DOCUMENT 00 90 00 ADDENDUM

ADDENDUM NO. [2] Date: August 1, 2018

RE: SOUTHWEST WISCONSIN TECHNICAL COLLEGE

COLD STORAGE BUILDINGS

BLDG 1200B - SITE PLAN

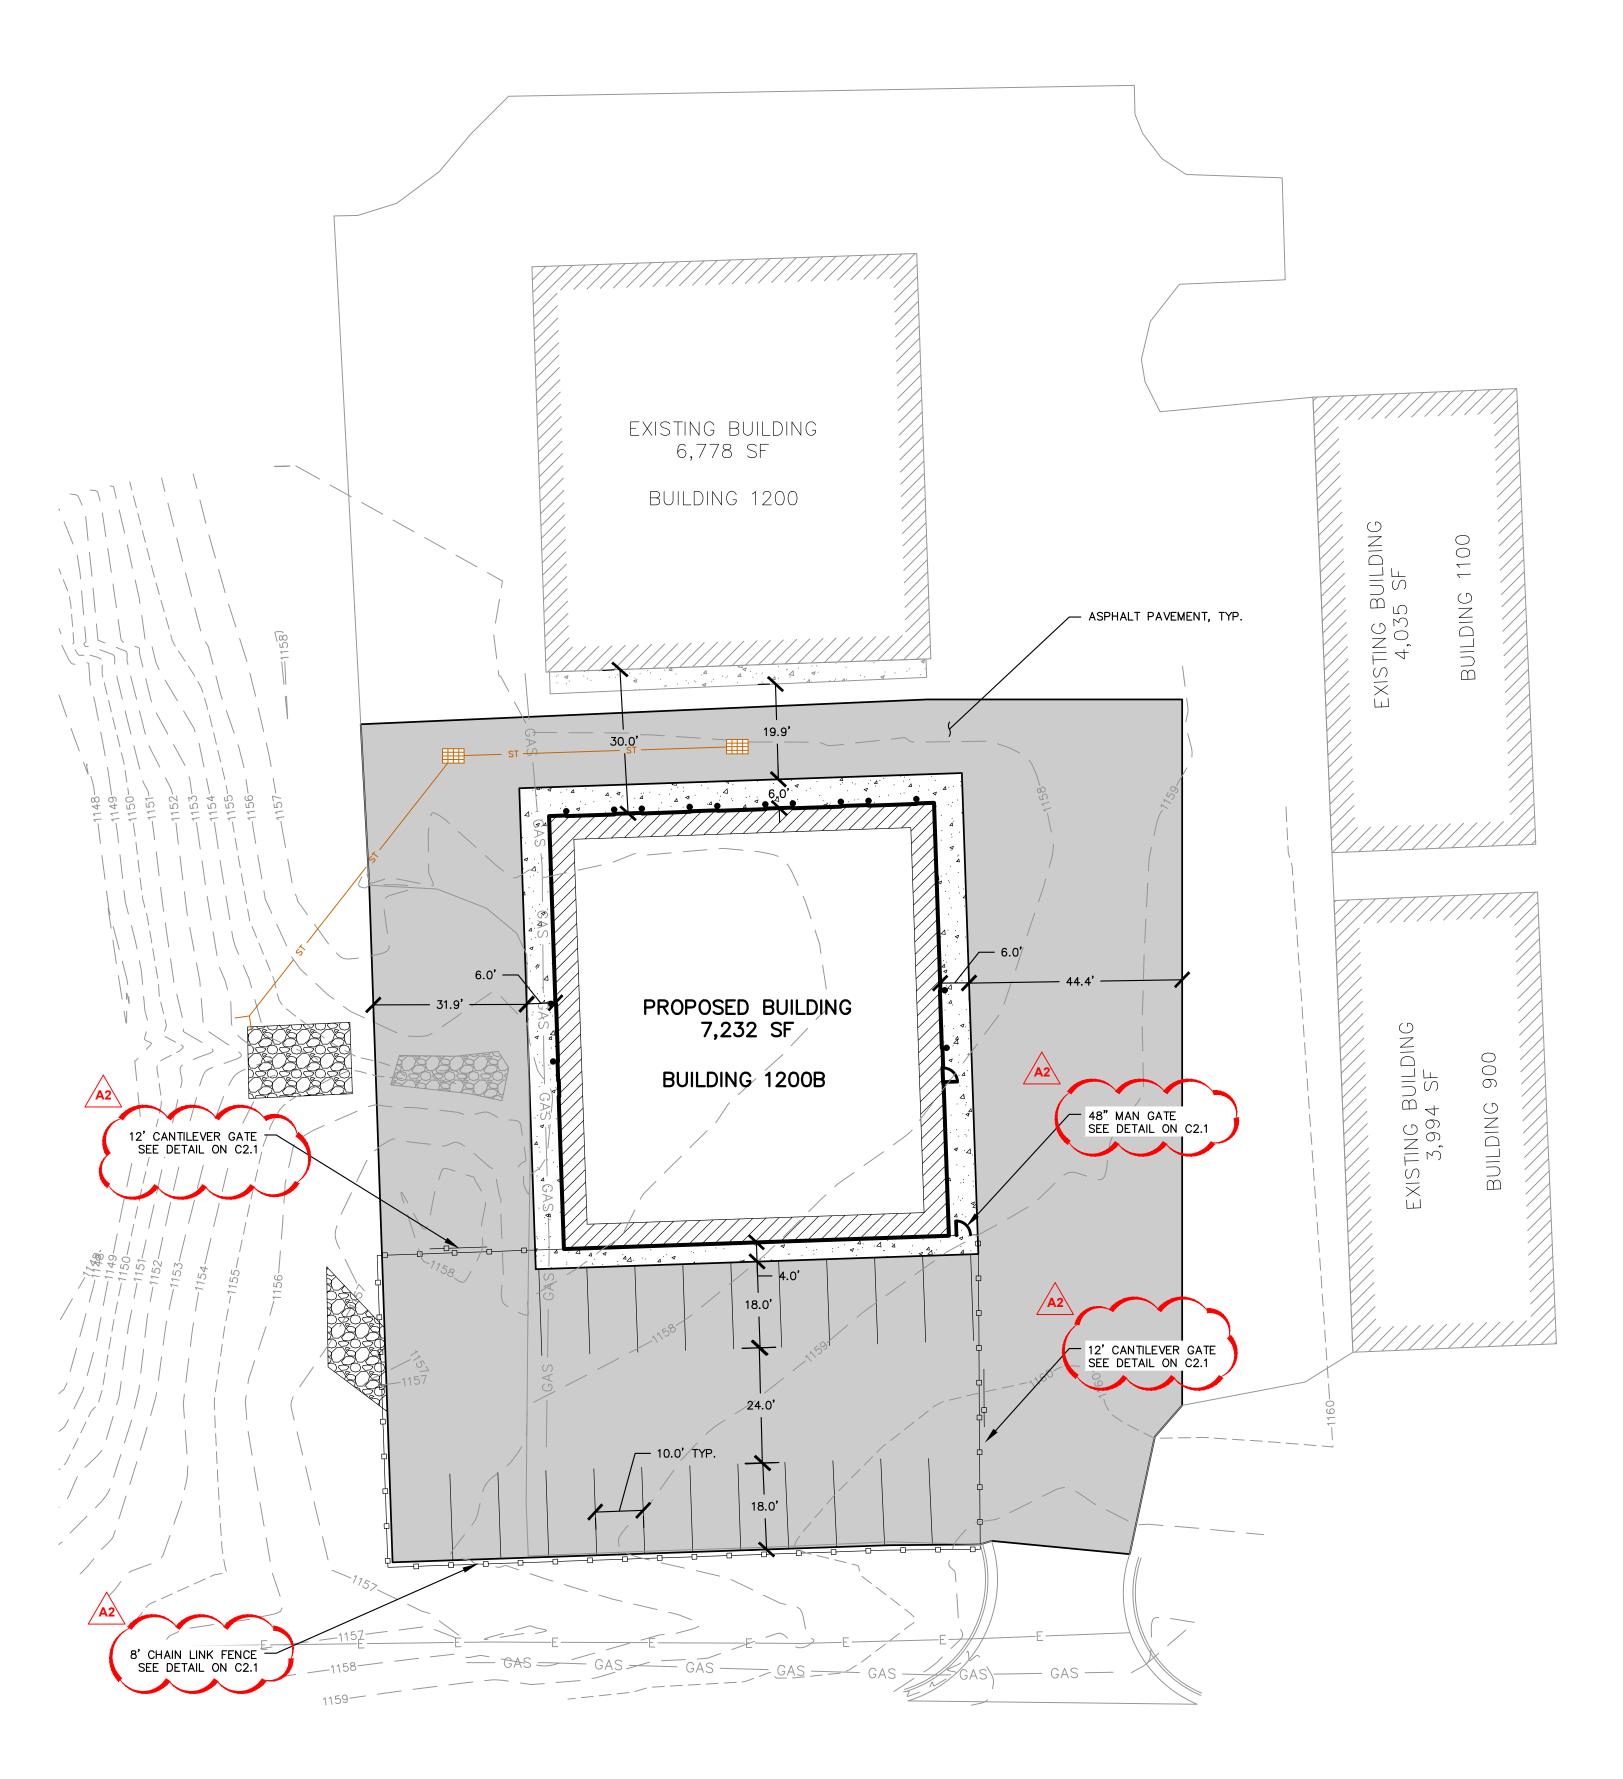
- 3. Sheet C2R1 SITE PLAN 24 x 36 attached hereto.
 - a. Revisions regarding perimeter fence clouded on Drawing.
- 4. Sheet C2.1 SITE PLAN DETAILS 24 x 36 attached hereto.
 - a. Add Drawing as part of Contract Documents.
 - b. Site fence details and specifications.
